#### LIMA ALLEN COUNTY REGIONAL PLANNING COMMISSION SUBDIVISION ADMINISTRATOR'S REPORT

CASE NO.	:	Springbrooke Estates Replat
DATE OF REVIEW BY THE DEVELOPMENTAL		
CONTROLS COMMITTEE	:	February 16, 2021
PETITIONER(S)	:	Brittiney L. Cozad
REASON FOR REPLAT	:	Extending the parcel to the rear
DESCRIPTION OF PARCELS	:	37-0702-04-010.000
LOCATION OF PARCELS	:	NW ¼ of Section 7, T3S, R7E, Bath Township

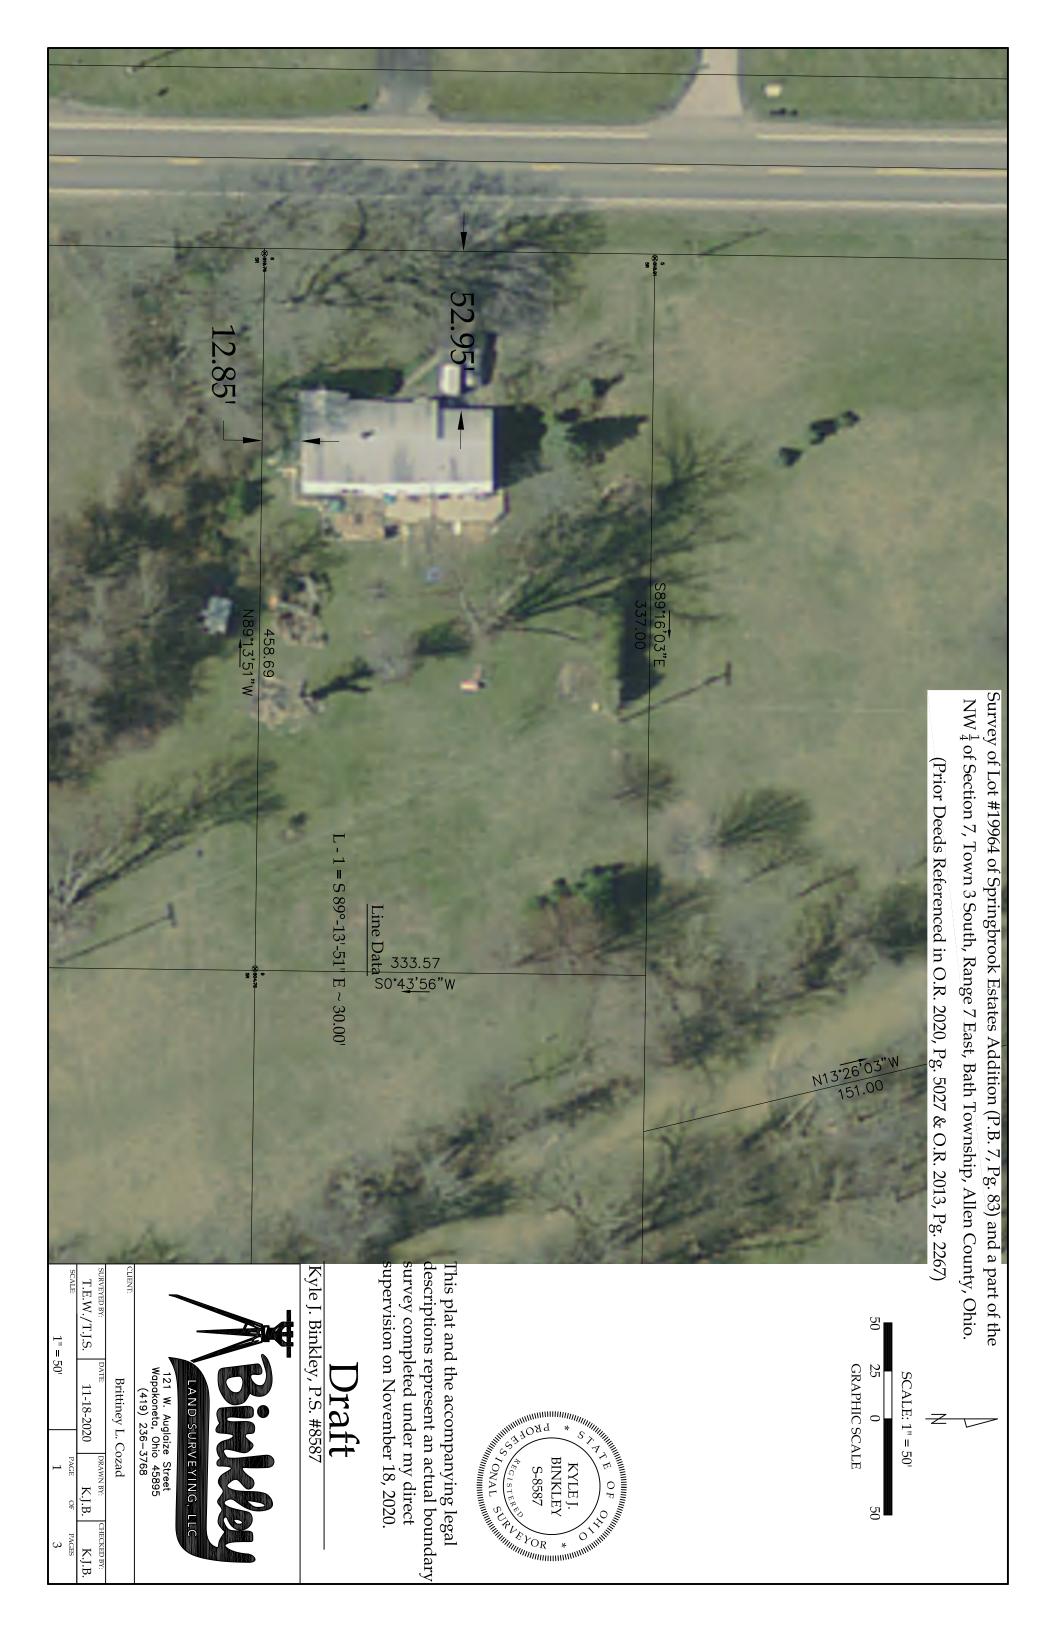
The Springbrooke Estates Subdivision was originally platted in September of 1945 with the approval of the Allen County Auditor. The existing subdivision currently has full access to public water, sewer, electric, and public roadways. The subdivision plat was reviewed to confirm its continued compliance with the current township zoning and setback regulations, which have all been met. Further, review has been conducted in order to confirm the proposed replat site's compliance with other possible site restrictions, including wetlands, floodplains, historical and archeological, as well as roadways access, and county lot restrictions. Again, none of these potential issues were determined to be a problem at the proposed replat site. The proposed Parcel will be served by N. West Street (SR. 115), which is categorized as a major collector on the federal functional classification system. While this roadway is listed on the state access management plan this replat is neither creating any new lots nor adding any new access points onto the roadway, therefore the access management rules are not applicable in this case. Additionally, because no new points of access are being added to the roadway, no additional traffic should be produced by the proposed replat. The owner of the lot in question wants to extend the rear of her parcel so she no long abuts any other property owners along the rear of her property, this is being done in an effort to avoid any potential future land disputes.

The subdivision is currently zoned R-1 Residential in Bath Township and the owner is not proposing a change in either zoning or usage. All minimum setbacks and lot restrictions established by the township are met by the proposed lot. The proposed lot meets all other specific requirements established by both the Township, Subdivision, and County. Please note that almost the entire parcel is within the FEMA identified Special Flood Hazard Area, the owner has been made aware of this fact and does not intend to develop the area added to the property by the proposed replat.

The Staff recommends approval as submitted.
